## Appendix 1 – Submission Points Table

Council Submission on PC14

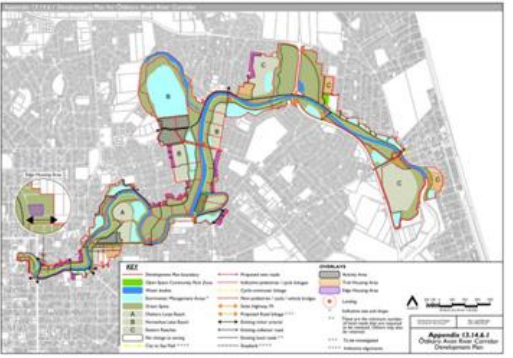
9.4 - Significant Trees (Riccarton Bush)	N/A	9.4.4.1.3.RD6	<p>The phrasing proposed for RD6 appears to have been an oversight, for the simple reason that there is no ability to measure tree trunk when the rule specifies that the trunk is the predator-proof fence. The original rule deliberately used the predator-proof fence as the base for measurement to make the measurement easier and uniform, and apply to mature trees as well as saplings that, without disturbance or damage will eventually grow. Another reason for using the predator-proof fence as a “base of a tree” within the old City Plan rules was that Riccarton Bush is treated as one entity, rather than a collection of individual trees within, and is shown as such on the maps.</p> <p>In this respect, a more appropriate control may simply be retaining the</p>	Decline the change to insert the 'tree protection zone radius' and maintain the 10m setback control.	None.

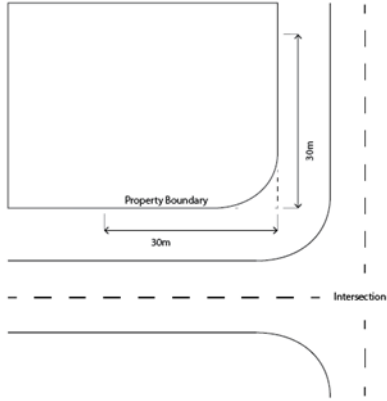
Chapter	Map	Provision # / Address	Submission	Decision Requested	Attachment(s)
14 - Residential	N/A	14.4.1.1 P10-12	Within the Residential Suburban and Residential Suburban Density Transition Zones in chapter 14, permitted activities P10-P12 refer to an outdated tsunami map which can now be replaced with the Tsunami Management Area qualifying matter extent.	Remove the text with strikethrough and add the text in bold underline - <del>the tsunami inundation area as set out in Environment Canterbury report number R12/38 "Modelling coastal inundation in Christchurch and Kaiapoi from a South American Tsunami using topography from after the 2011 February Earthquake (2012), NIWA"; as shown in Appendix 14.16.5;</del> <b><u>The Qualifying Matter Tsunami Management Area;</u></b>	None.

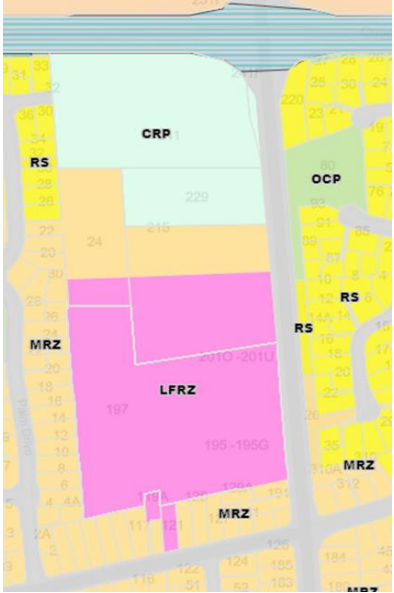
15.15 - Commercial Appendix	N/A	Appendix 15.15.12 +13	The key for Appendix 15.15.12 and 15.15.13 is unclear on what specific lots are subject to the rules in chapter 15.10.	Add "Sites subject to' to the key of Appendix 15.15.12 and 15.15.13 so it reads "Sites subject to shared pedestrian/cycleway 8m wide connection" and "Sites subject to greenway 12m wide connection".	None.

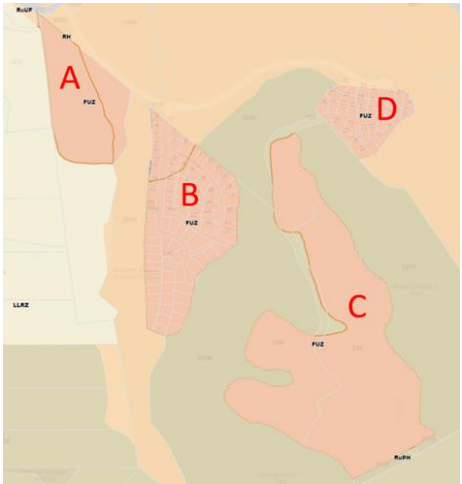
Chapter	Map	Provision # / Address	Submission	Decision Requested	Attachment(s)
			<p>Policy 5.2.2.5.2 Managing development within the Qualifying Matter Tsunami Management Area. On planning map 25 there are parcels notified as High Density Residential Zone however a more appropriate zone is submitted to be the RSDT Zone. Similarly some properties zoned RS and RSDT Zone have been incorrectly changed to MRZ instead of retaining the current zoning. Again, these changes are submitted to be more effective in achieving proposed Policy 5.2.2.5.2.</p> <p>On Nayland Street in Sumner RMD zoning is still showing (which is no longer a proposed zone), and it is submitted a more appropriate zone is the operative RSDT Zone. While the submitted extent of changes to the underlying zoning of the identified parcels is a significant change to the notified proposal, the changes are consistent with the notified section 32 evaluation (section 6.16).</p> <p>Further, the changes to the zoning and associated planning maps, are</p>
